D McKean comments on outline planning approval 19/00836/OUT 25th Jan 2022 for 265 Houses at Eyebury Rd dated 25th Jan 2022 has a comprehensive report and 34 conditions to be complied with along with the S106 agreement items.

Larkfleets Flood Risk Assessment dated Oct 2017 Ref No MA10525-FRA-R01: Section 3.2.6 states:-

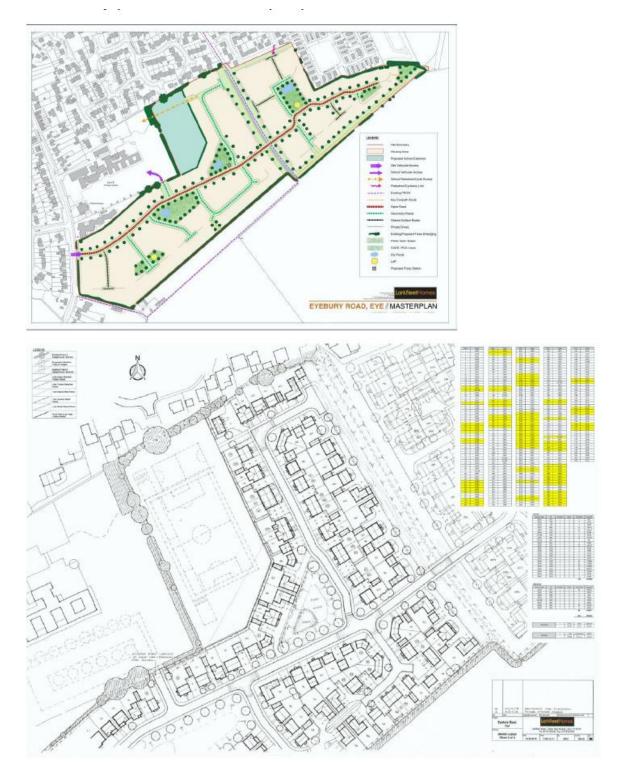
Anglian Water need to upgrade the sewer pipes due to the size of this development at Little Close exit, these need completing before the first house is occupied

In order to mitigate the impact of the proposed development upon the network, AW has recommended the following:

1. Upsize 112m length of 225mm diameter sewer to 650mm diameter situated on the corner of Eyebury Road and Little Close.

2. Upsize 44m length of 300mm diameter sewer to 825mm diameter situated on St Michaels Walk near Eye- Little Close pumping station.

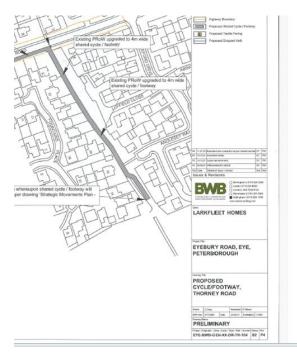
C25 states Prior to commencement of development, further details of the works to Eyebury Road and a timetable for its implementation shall be submitted to and No dwelling on the development shall be occupied until all of the works have been completed.

These traffic calming measures are needed before commencement of the site as already Eyebury road has significant Issues with traffic and the safety to our school children which will become much worse with site traffic.

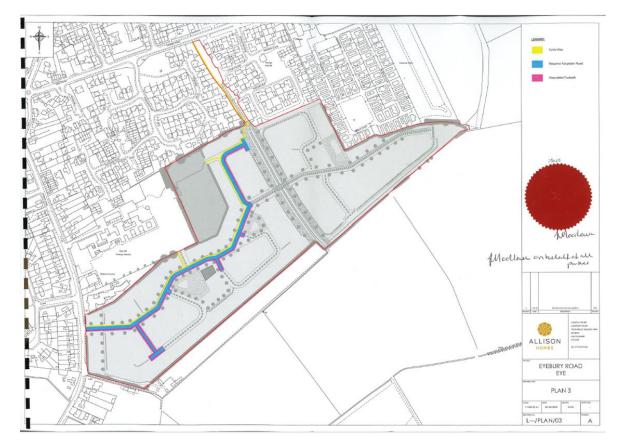
The S106 Document drawing does not show the adoption of the roads footpaths or any cycle ways way to the East of the main drain?

8 With the exception of minor proposals of very limited consequence to the overall redevelopment of the entire site, the council will not approve any detailed planning proposals for any parts of the site until, and subsequently in accordance with, a comprehensive planning permission for the entire site has been achieved (including any agreed Planning Obligation to ensure specific elements of the wider scheme are guaranteed to be delivered) Why does the S106 Document Plan not show the adoption of roads footpaths or any cycle ways way to the East of the main drain?
